RE: 5508 Valiente Rd. NW
Grading and Drainage Plan
Engineer's Stamp Date: 01/22/20
Hydrology File: C11D005

Based upon the information provided in your resubmittal received 01/22/20, the Grading and Drainage Plan is approved for Building Permit.

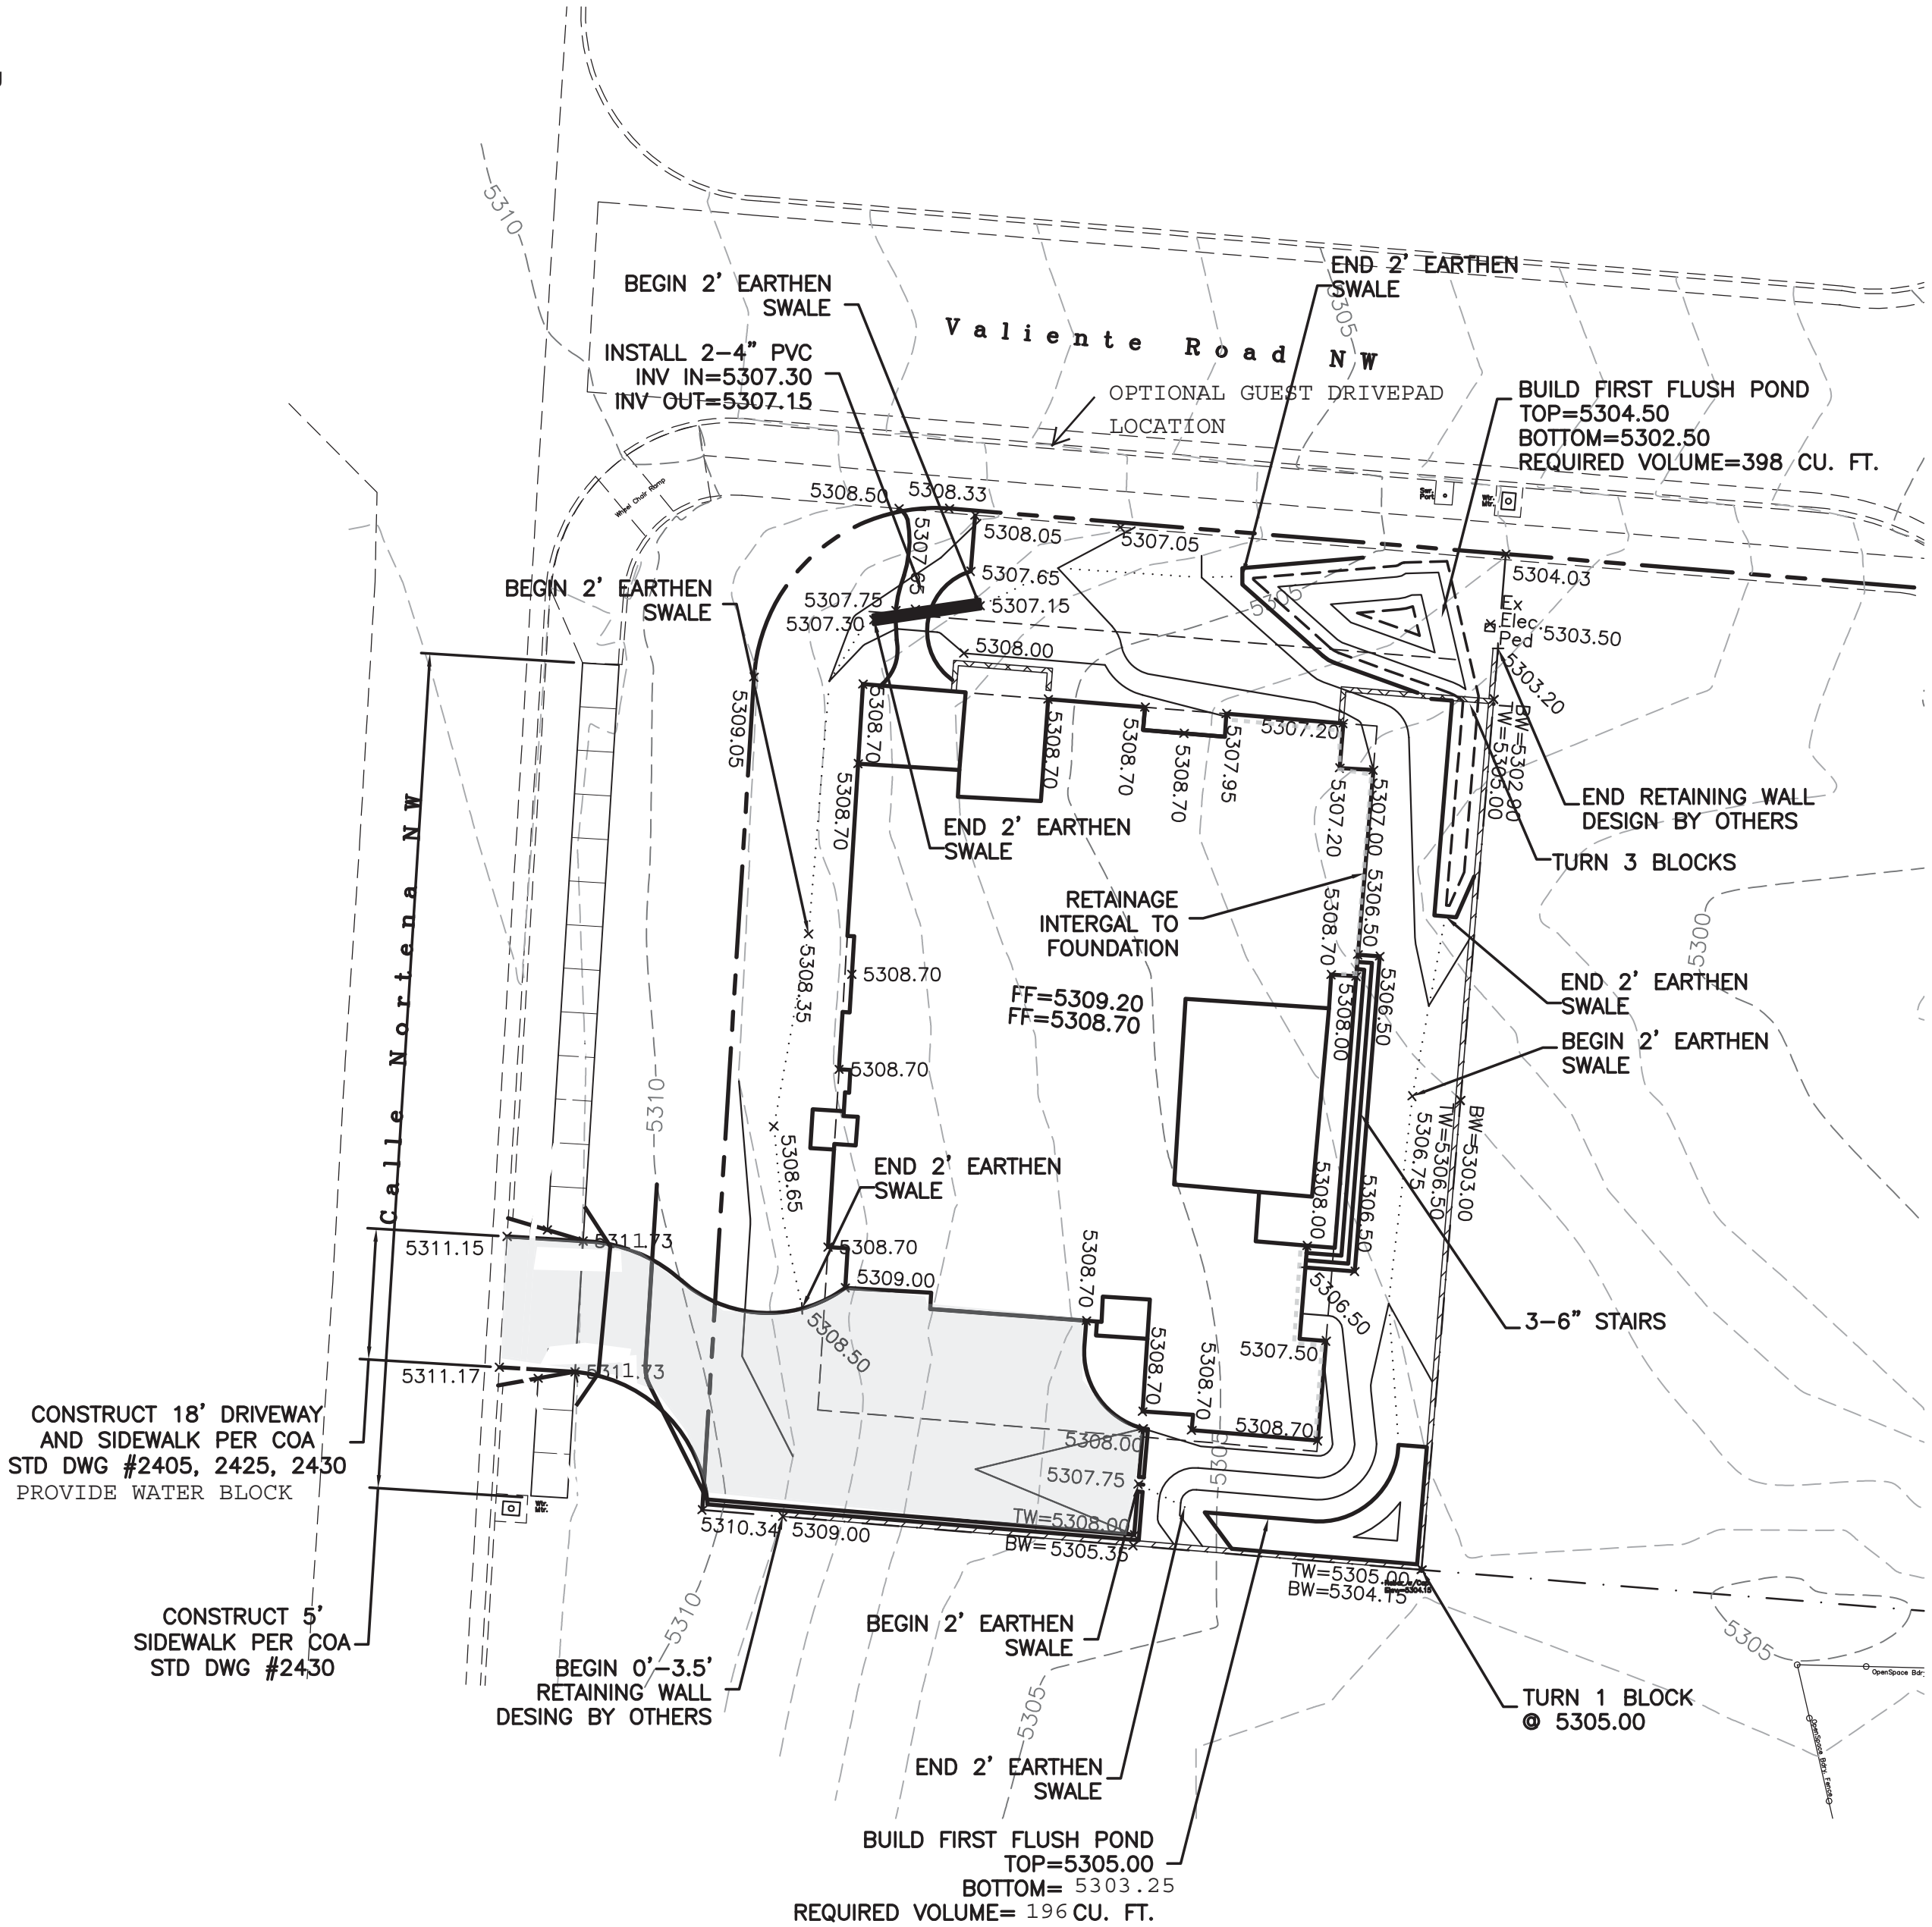
Once the grading is complete, a pad certification will be required prior to release of Building Permit. Please attach a copy of this approved plan in the construction sets for Building Permit processing along with a copy of this letter and the pad certification approval letter.

Prior to approval in support of Permanent Release of Occupancy by Hydrology, Engineer Certification per the DPM checklist will be required. Also a formal Elevation Certificate needs to be submitted to Hydrology.
